15 September 2025

**Re: Global Stability Study for Eastern Slope near Building D
West Essex – Highlands Development
West Orange, New Jersey
Langan Project No.: 101049801**

As requested, in conjunction with the above-referenced study Langan Engineering and Environmental Services, LLC (Langan) has reviewed letters prepared by Princeton Hydro ("Princeton"), who has been retained by Objectors to the proposed Development. The Princeton letter, dated 16 July 2025, summarized their comments under four primary issues (below):

**Cross Section B_Proposed Condition
(GSI = 65)**

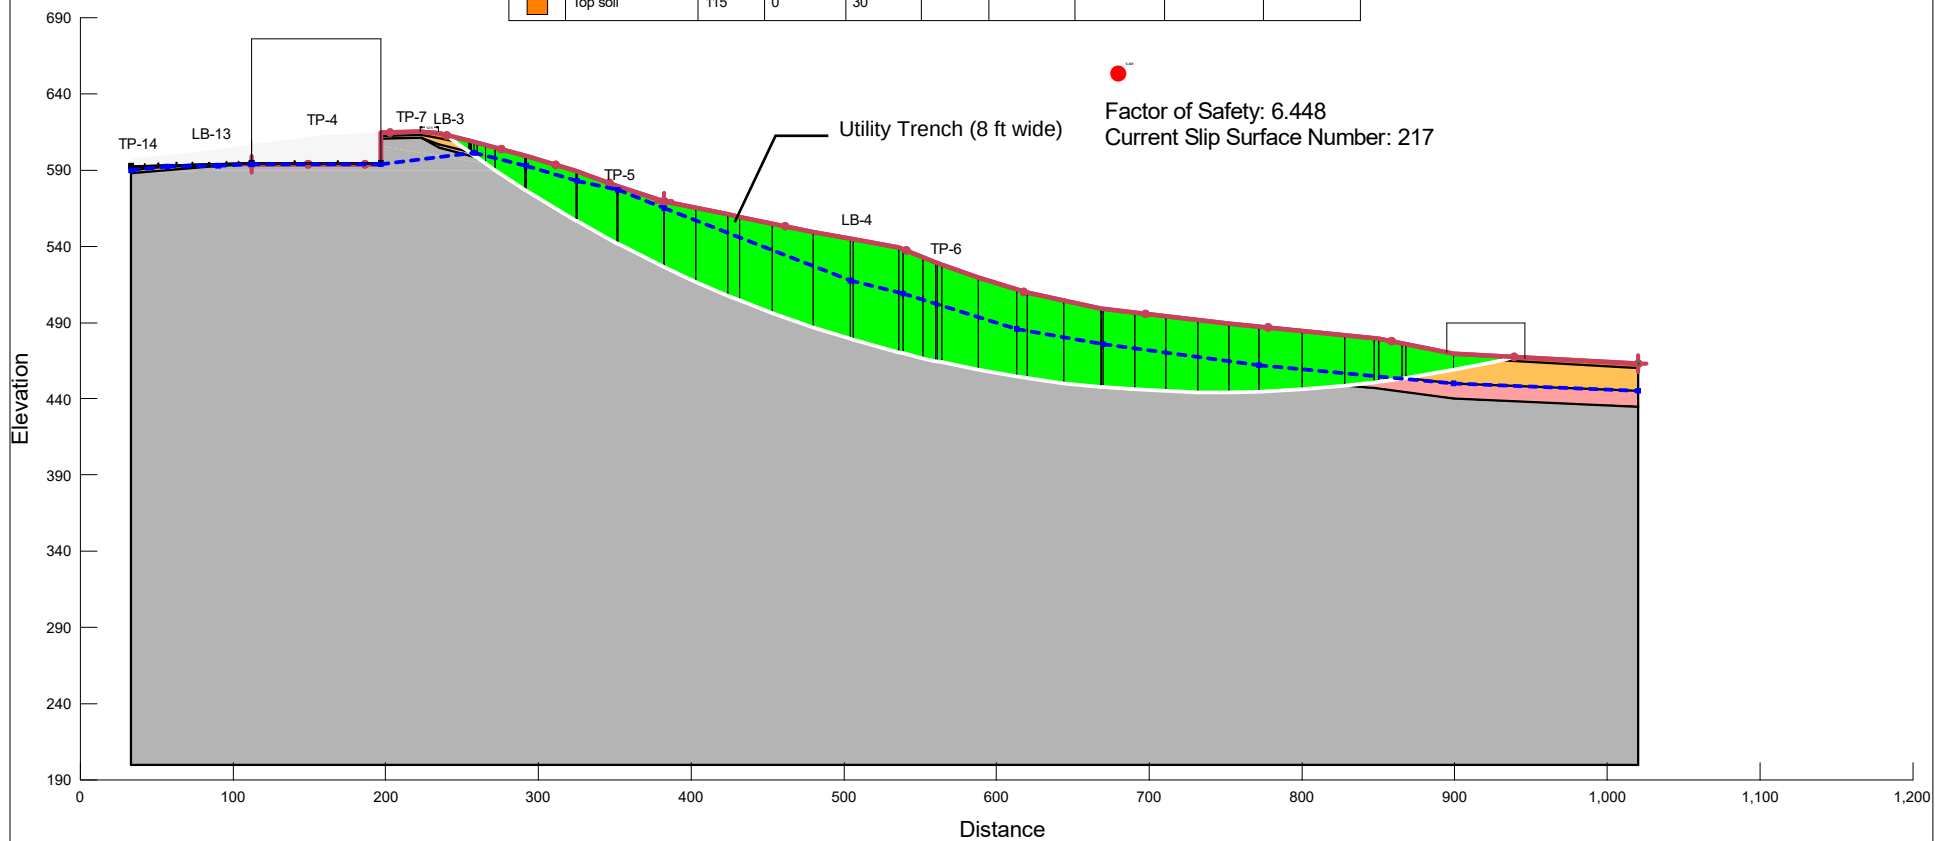
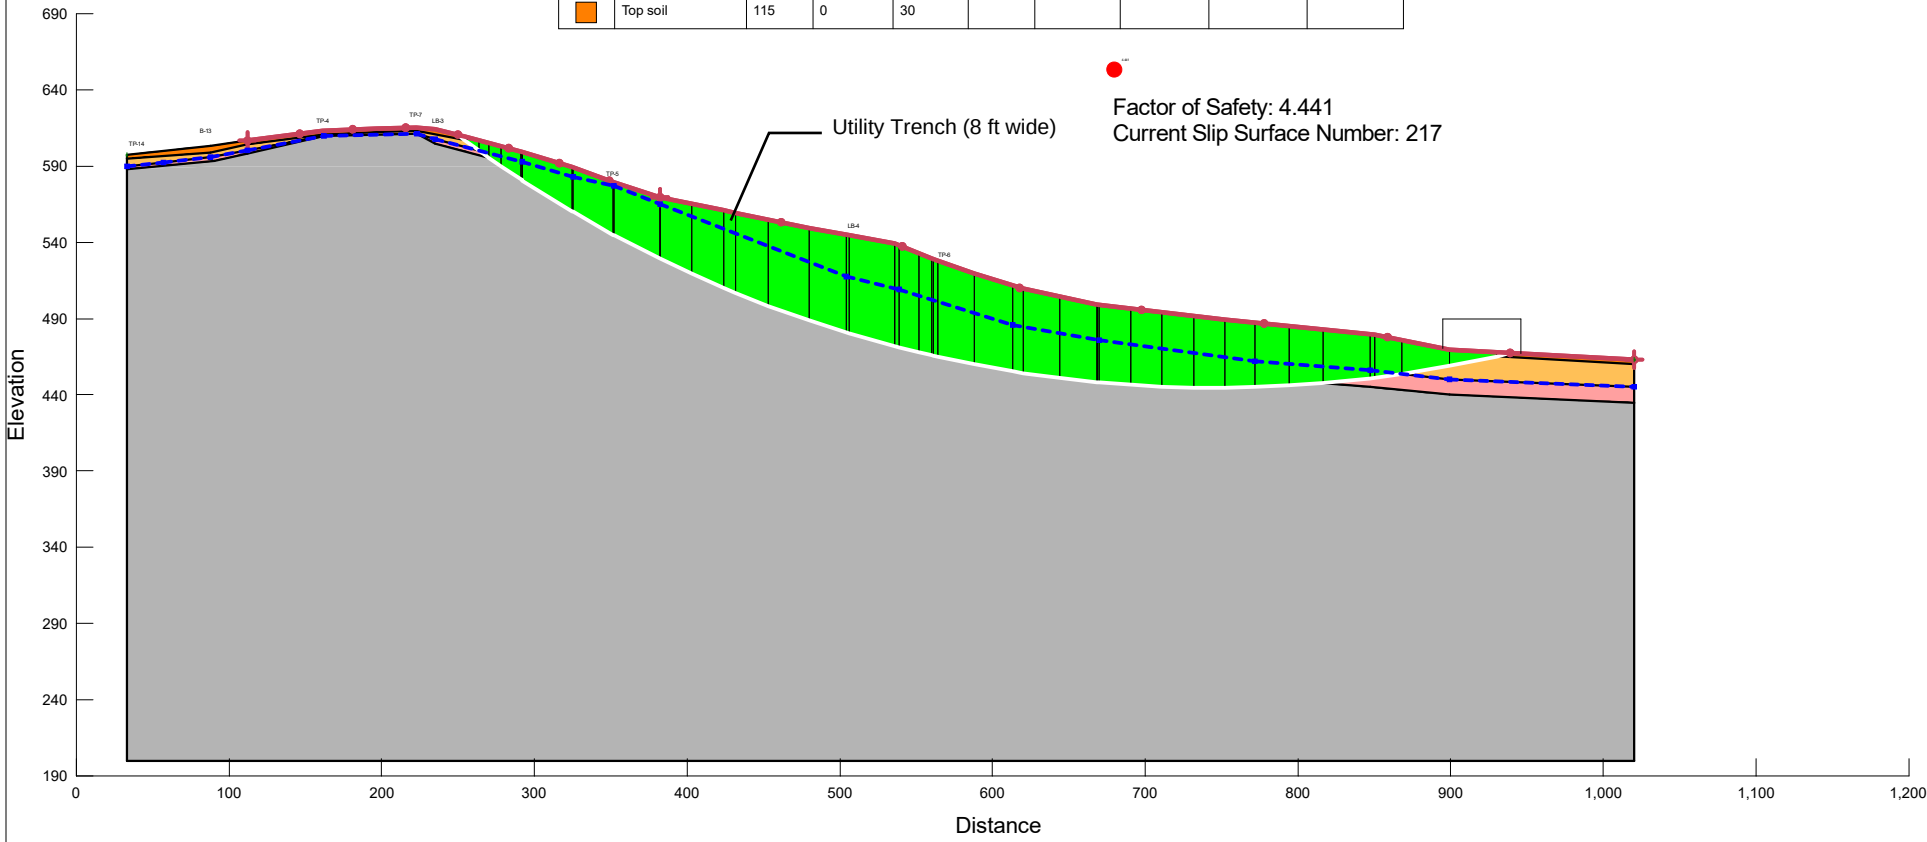
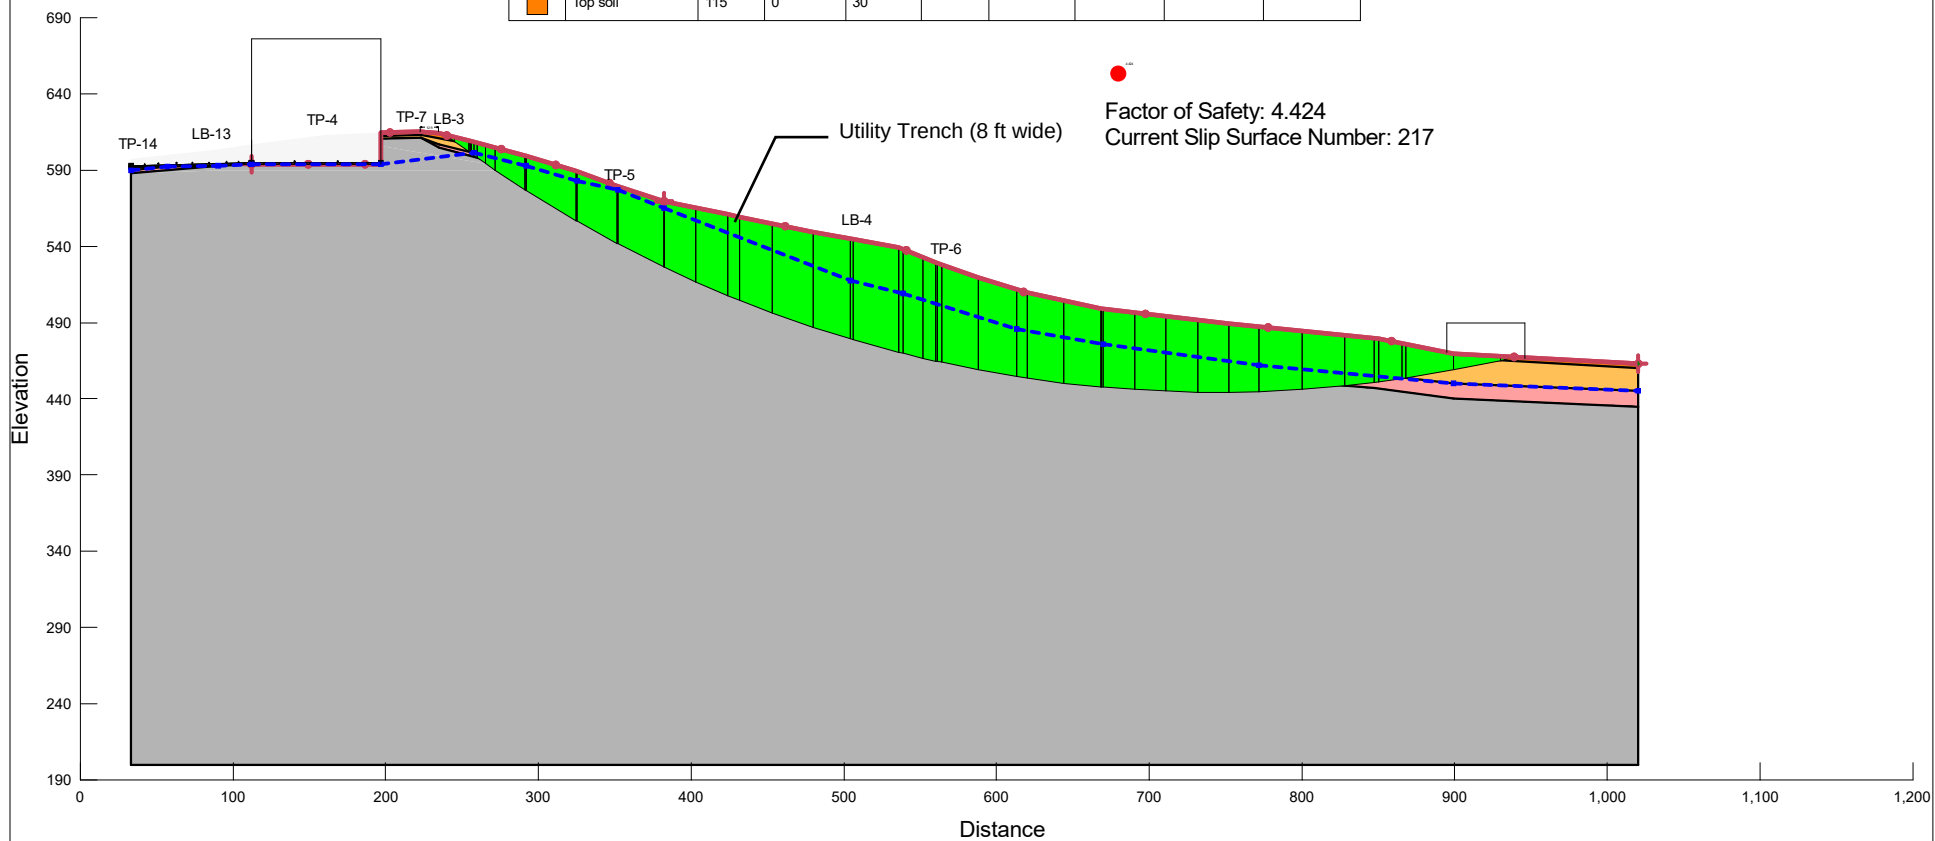
Langan Response: Princeton initially identified seven subparts associated with their position. Five of 7 relate to rock properties used in our model, one relates to building loading, and one relates to the presence of a sewer. In Princeton's 12 August letter they provided analyses using their interpretation of our data. Overall, Princeton repeatedly claims our design values are incorrect, yet they clearly misinterpret the data and mis-apply it.

We modeled our analysis sections A-A and B-B with the discontinuity of the wastewater utility line as a trench of medium dense sand having a friction value of 32 degrees extending from ground surface to the decomposed rock over 30 feet below the existing grade. Our models show that there is no change in the location of the critical failure surfaces or corresponding factors of safety (Exhibit B).

Cross Section C (Static Condition)

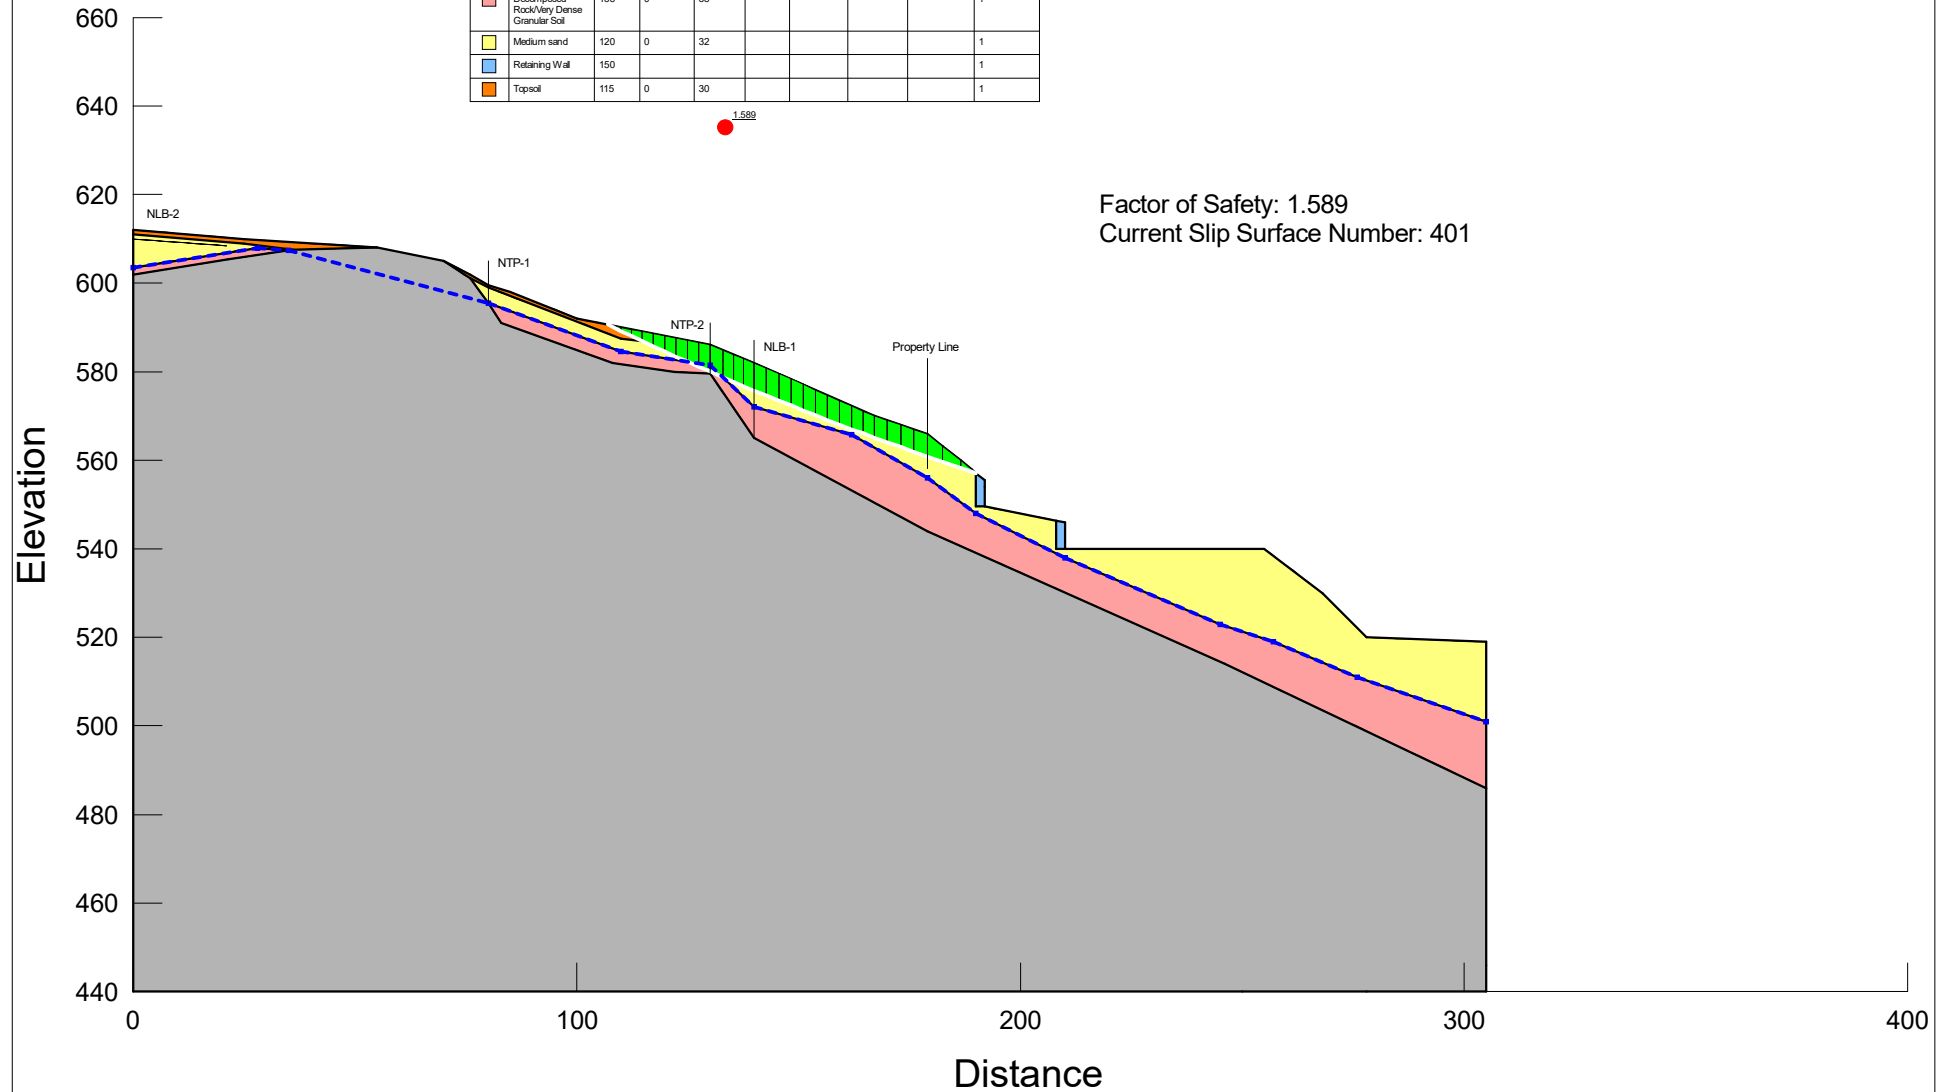
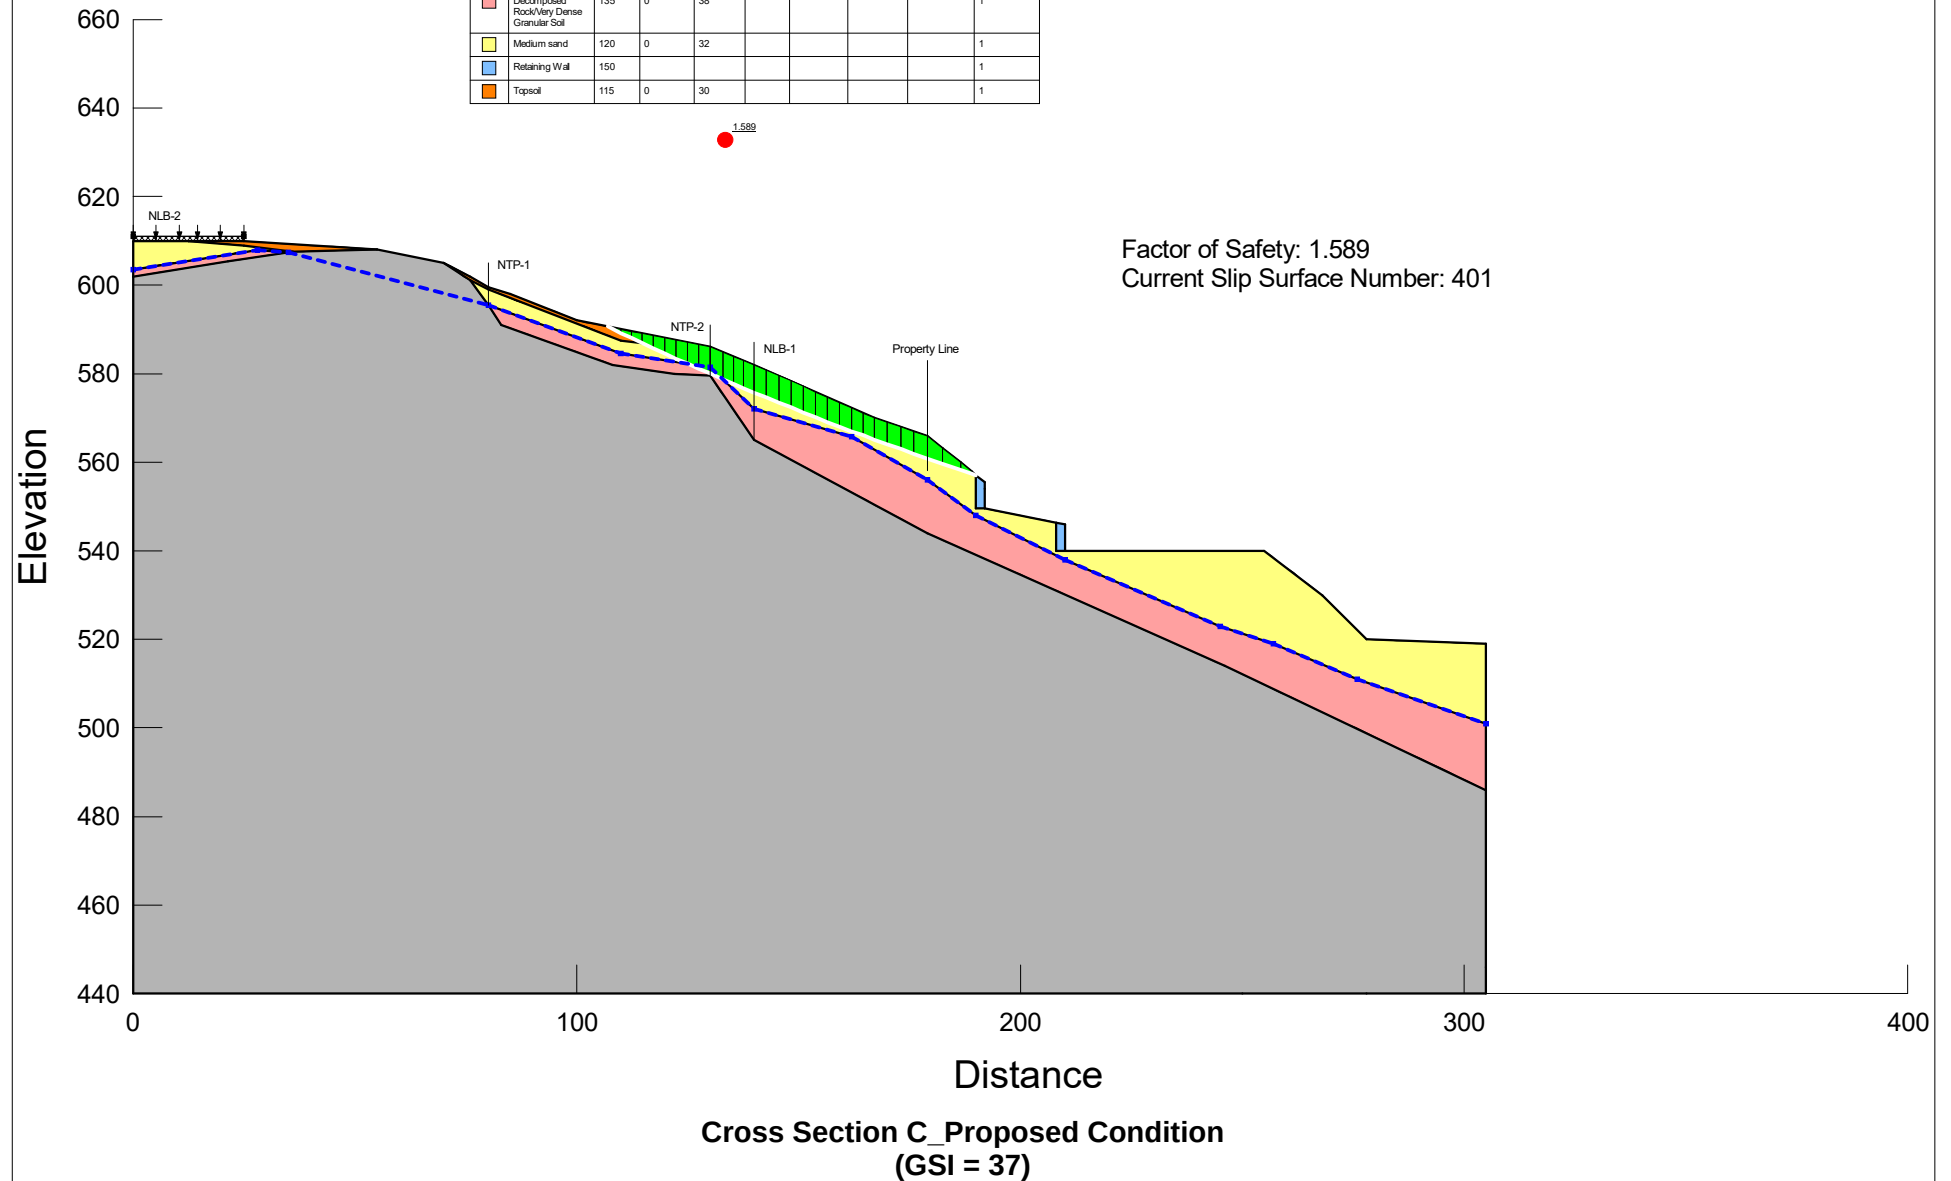
Princeton’s 12 August model of sections C and D utilized a GSI of 20 and a UCS of about 2300 psi. Rock material having the Princeton assigned values would equate to a very poor quality seamy/disturbed rock or a poor quality disintegrated rock. However, our summary of the rock structure and quality in the table below shows a narrow range in structure from predominantly blocky to very blocky (at one location) and generally good quality to fair quality rock. The upper 5 feet of the rock at NLB-1 (our analysis section C-C and Princeton’s model section C) exhibits rough slightly weathered joint conditions, which are considered Good surface quality within the GSI system, not very poor surface quality as suggested by Princeton. In addition, field estimates of typical intact rock strength are shown to range from roughly 3,625 psi to 36,250 psi, the upper end of which is more closely associated with basalt. Nonetheless, we modeled analysis section C-C using a GSI value of 37 and a comparatively low intact rock strength and there was no change in the factor of safety (Exhibit B). Rock core photos are provided in Exhibit C. Princeton’s reference to using a factor of safety of 2.0 is simply not applicable. The EM 1110-1-2908 reference is applicable to US Corp of Engineer facilities built on rock that experience a lateral load (e.g., a dam), which if the slope failed would be catastrophic to neighboring properties. This development clearly does not apply. A factor of safety of 1.5 is applicable for the subject slope.

Princeton also claimed we used incorrect values for the overlying soil in their 12 August letter. Their model of sections C and D use a thicker medium dense section than exists. We provide in Exhibit D a summary of the Standard Penetration Test N-values and their associated correlations to strength parameters for the soils encountered in our borings. We have stated that our design parameters are lower bound (conservative) values, as clearly shown in the graphic. Yet, Princeton continues to misinterpret the available data. In their 12 August models for sections C and D, they assigned 32 degrees friction to a 20-foot-thick section of soil, despite there being only one boring location (NLB-3) where a 4-ft-thick-layer of the upper sands was encountered to have N-values that correlate to 32 degrees. The average friction value for these soils in our Sections C-C and D-D are 39 degrees and 45 degrees, respectively.
